3.3 Plant Water Use

Figure 3.3-1 Water Use Diagram Summary

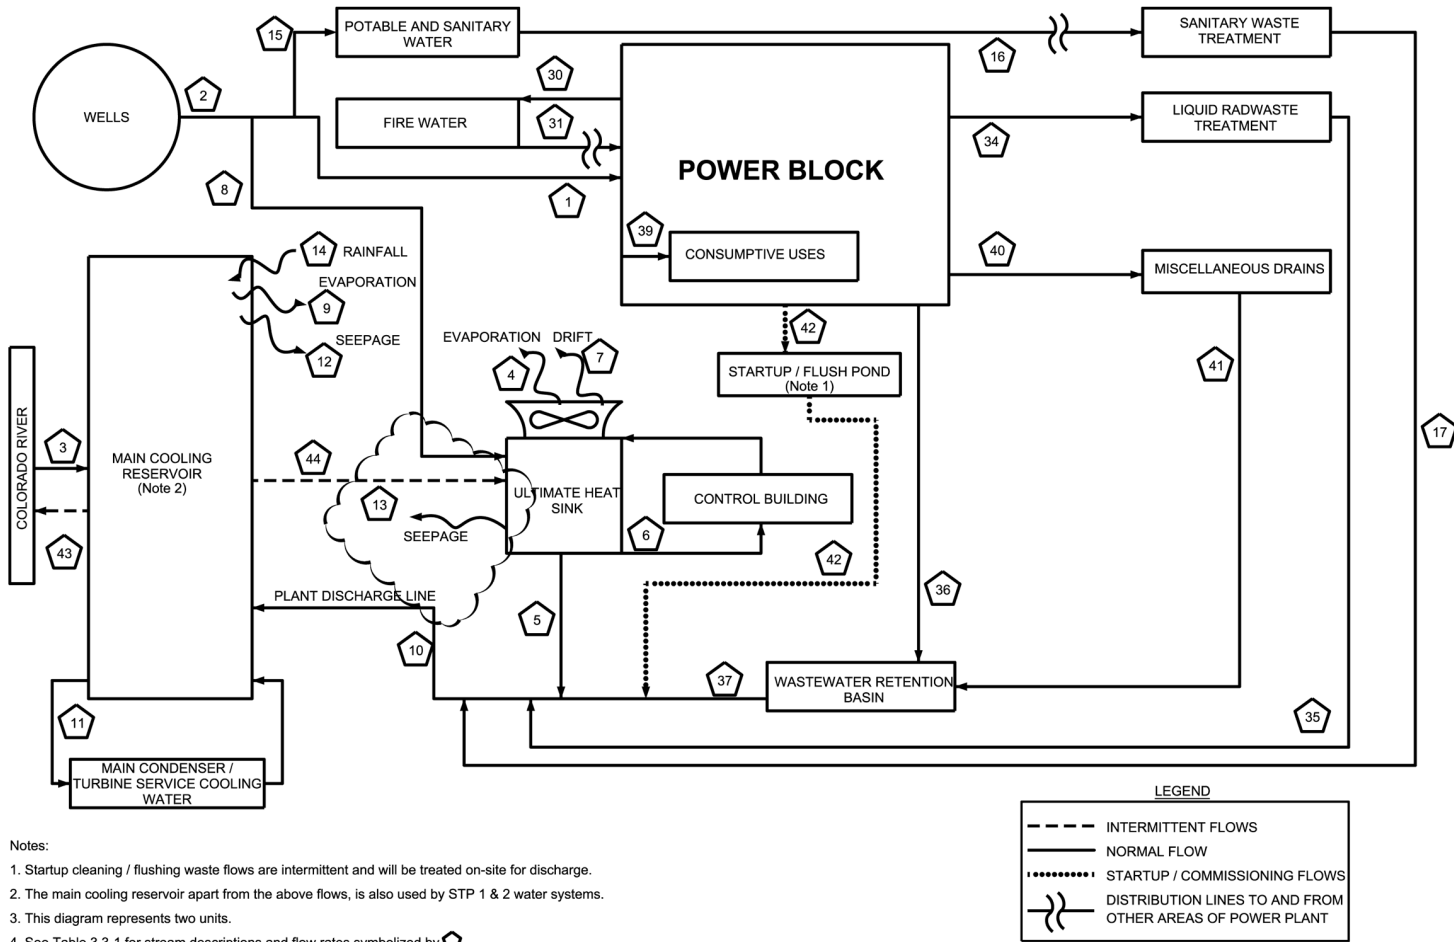
~~short-term steady-state conditions. STP 3 & 4 groundwater use is approximately 1,250 gpm on average, with a maximum of approximately 4,150 gpm.~~ During normal operation, approximately ~~391~~550 gpm of plant effluent water (UHS basin blowdown, filter backwash, etc.) is discharged to the MCR as surface water. Table 3.3-1 identifies the normal and maximum water and effluent streams for STP 3 & 4, and Figure 3.3-1 provides a diagram to illustrate the normal operation flows.

Stream	Stream Description	Normal [1] (gpm)	Maximum [1, 2, 7] (gpm)	Comments
	Groundwater (Well) Streams			
2	Plant Well Water Demand	9751,242	34344,108	[11]
8	Well Water Demand for UHS System Makeup	885	3,203	[11]
4	UHS Tower Evaporation	566	2,122	
5	UHS Tower Blowdown	290283	1,058	[4]
6	UHS Tower Circulating Water Flow	85,590	128,400	
7	UHS Tower Drift	5	10	[3]
<u>13</u>	<u>UHS Seepage</u>	<u>24</u>	<u>13</u>	
1	Well Water for Power Plant Makeup/Use	50332	91805	[6]
15	Potable Water	4025	40400	
16	Sanitary Waste	4025	40400	
19	Filter Effluent	50332	91805	
20	Filter Backwash Water	317	540	
21	Filter Backwash Waste	317	540	
27	Demineralized Water to Various Users	22200	48500	[8]
22	Reverse Osmosis Influent	33300	72750	
23	Reverse Osmosis Effluent	22200	48500	
24	Reverse Osmosis Reject	11400	24250	
26	Mixed Bed Effluent	22200	48500	
34	Liquid Radwaste Treatment Influent	2840	60280	
30	Fire Water System Makeup	10	10

Stream	Stream Description	Normal [1] (gpm)	Maximum [1, 2, 7] (gpm)	Comments
Surface Water (Colorado River) Streams				
3	Total Required River Water to MCR	22,799 22,660	47,489 24,837	[10]
43	Total Discharge from MCR to River	0	138,240	
Plant Effluent Streams				
10	Final Effluent Discharge Line to MCR	391 530	1,511 1,818	[10]
35	Treated Liquid Radwaste	284 0	260 280	
37	Wastewater Retention Basin Discharge	33 182	53 380	
41	Demineralized Users Miscellaneous Drains Discharge	5 50	10 75	
17	Treated Sanitary Waste	40 25	140 100	
36	Total Low Volume Waste	28 132	43 305	
29	Equipment/Floor Washdown Waste	5	5	
31	Fire Water System Losses	10	10	
33	Oil/Water Separator Effluent	15	15
